Kalamazoo Public Library - Central

ADA Accessibility Site Survey:

Report Date: 10/3/19

Report by:
Paul Ecklund, ADA Specialist
Max Hornick

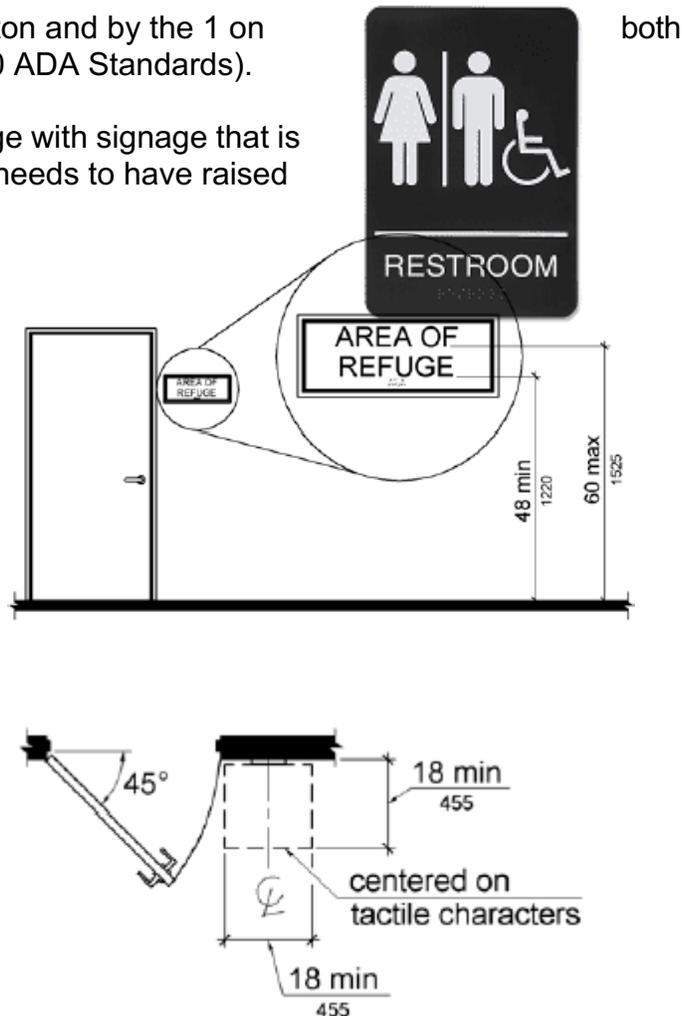
Fixed room signage is decorative but out of compliance with the ADA Standards.

Replace the decorative fixed room signage with signage that is ADA compliant. The fixed room signage needs to have raised characters (1/32 inches above their background). All characters should be in upper case, sans serif font and in high contrast to the background, with braille (Grade 2) directly under the characters. The signs should be installed so that the baseline of the lowest characters are no lower than 48 inches above the floor and so the baseline of the upper most characters is no higher than 60 inches above the floor ([703.4.1](#), 2010 ADA Standards).

These fixed room signs need to be located so that there is 18 inches by 18 inches of clear space centered on the center of the tactile characters on the latch side and out of the swing of the door ([703.4](#), 2010 ADA Standards).

Fig. 604.5.1 Side Wall Grab Bar for Water Closet

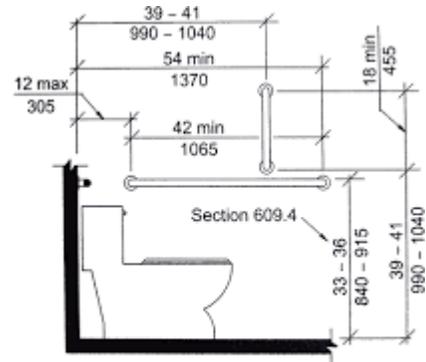
The toilet stall is accessible with appropriate turning space, side and rear grab bars are properly installed but the Vertical grab bar is too close to the rear wall

Remove urinal door (404.2.3, 2010 ADA Standards) and relocate the vertical grab bar so that it is 39 – 41 inches from the rear wall and 39 – 41 inches above the floor. (604.5.1, ICC/ANSI A117.1 Standards).

OPAC Station

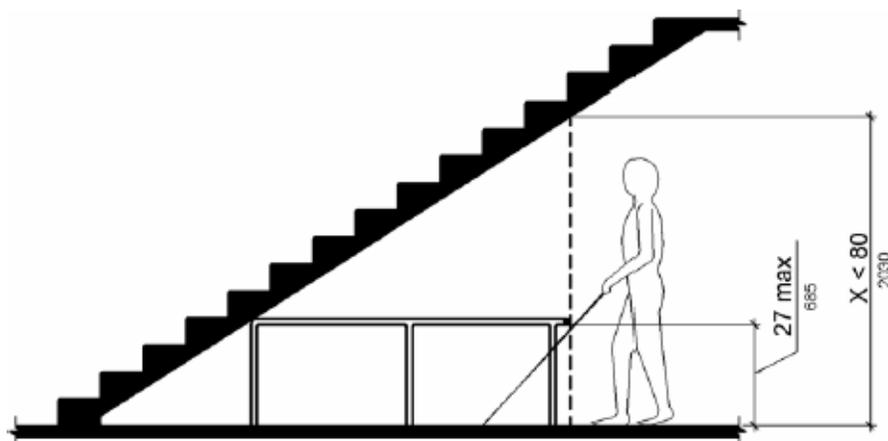
There are a couple of stations where the top of the touch screen (at 54 to 55.5 inches) is beyond the upper limits of an accessible reach range (at 48 inches). The stations protrude out (9 - 10 inches) into the path-of-travel beyond an allowable range of 4 inches and is not cane detectable.

The OPAC Stations need the touch screens lowered so that the top of the screen is within the accessible reach range of 48 inches (308.2.1, 2010 ADA Standards).

Something needs to be placed under the protruding sides or extending down from the other edge to make it cane detectable, e.g. placing planters on the floor under both sides of the protruding parts ([307.2](#), 2010 ADA Standards).
